SUBJECT: Forwards two sections of util 820201 draft Tech Specs, omitted due to duplication errors.

Subject: NUCLEAR PROJECT NO. 2
PARTIAL RESUBMITTAL OF DRAFT
TECHNICAL SPECIFICATIONS

WASHINGTON PUBLIC POWER SUPPLY SYSTEM
NUCLEAR PROJECT NO. 2

Technical Specifications
Appendix "A"
to
License No. ____

4.2.3 MCPR, as a function of core flow, shall be determined to be equal to or greater than the applicable limit determined from Figure 3.2.3-1:

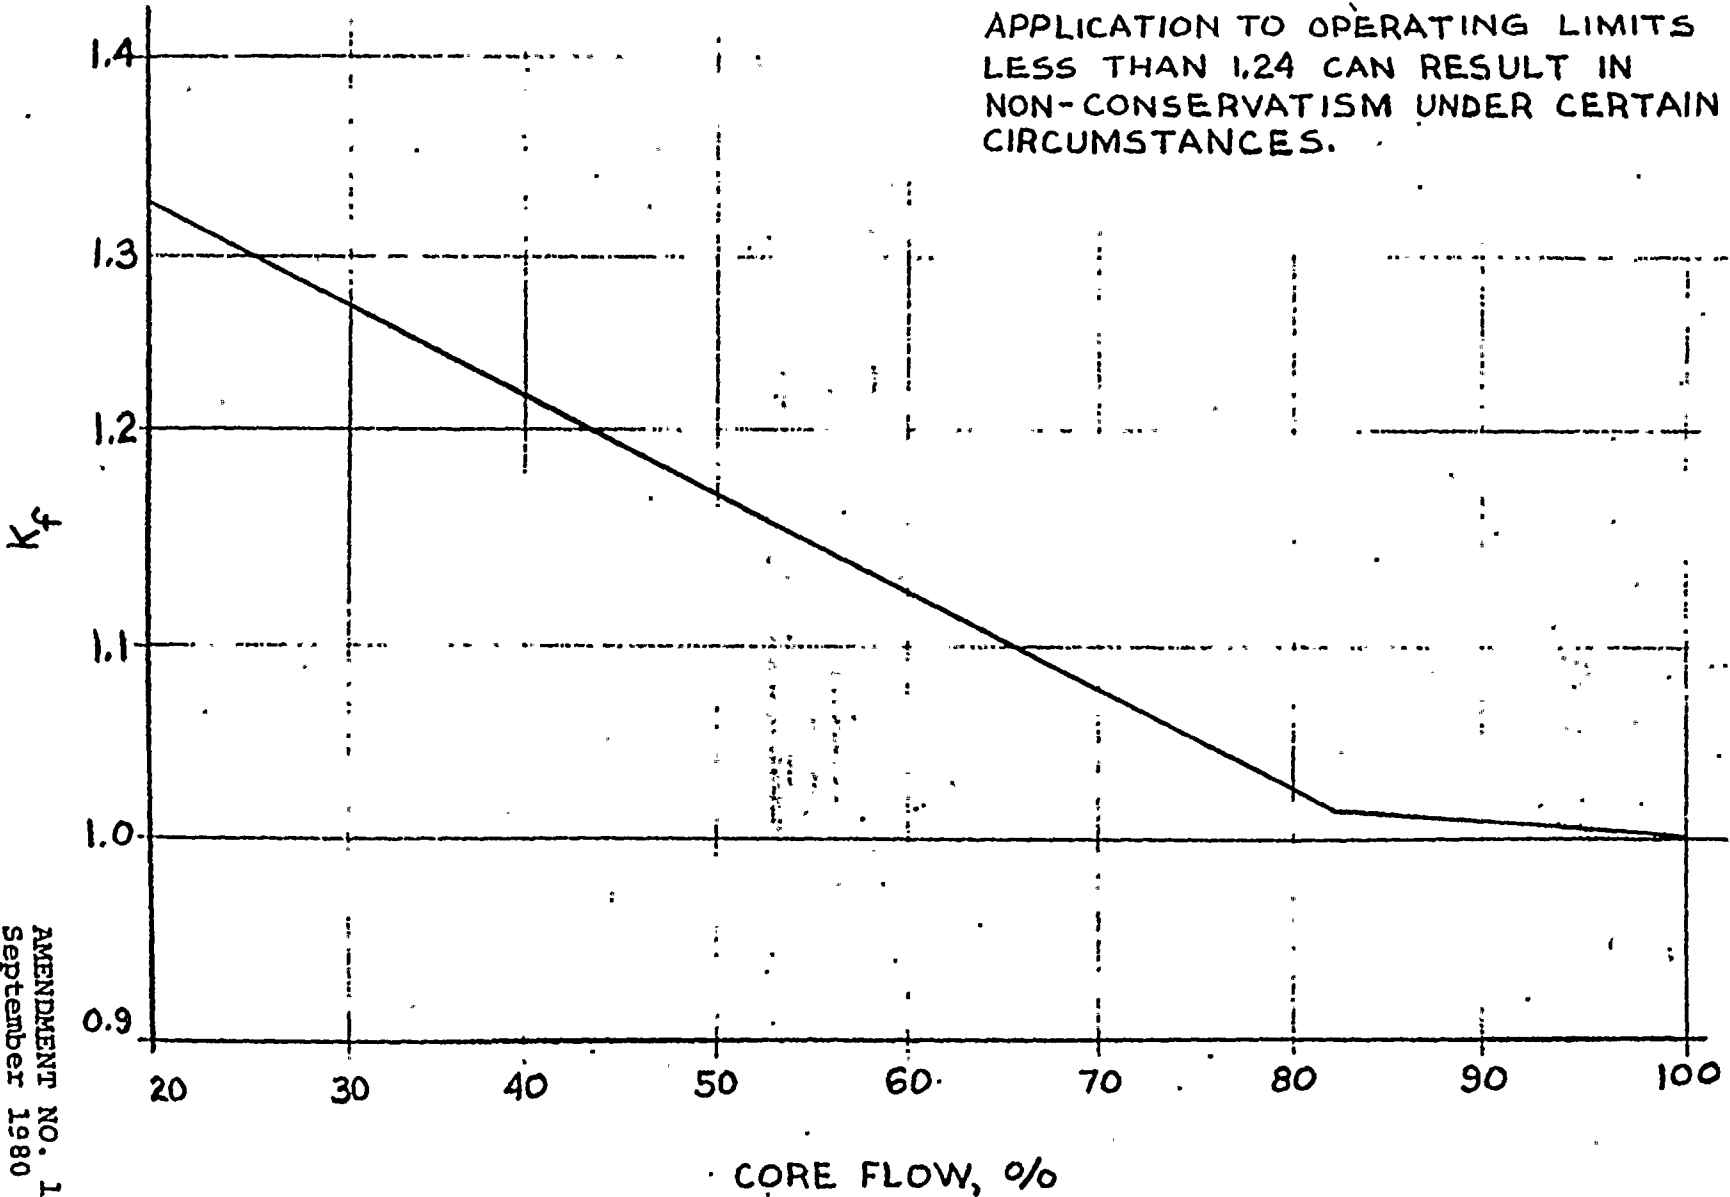
use this for figure 3.2.3-1

3.2.3 The MINIMUM CRITICAL POWER RATIO (MCPR), as a function of core flow, shall be equal to or greater than MCPR times the K_f shown in Figure 3.2.3-1, (provided that the end-of-cycle recirculation pump trip (EOC-RPT) system is OPERABLE per Specification 3.3.4.2), with MCPR for 8 x 8 fuel = ~~(1.20)~~: 1.24
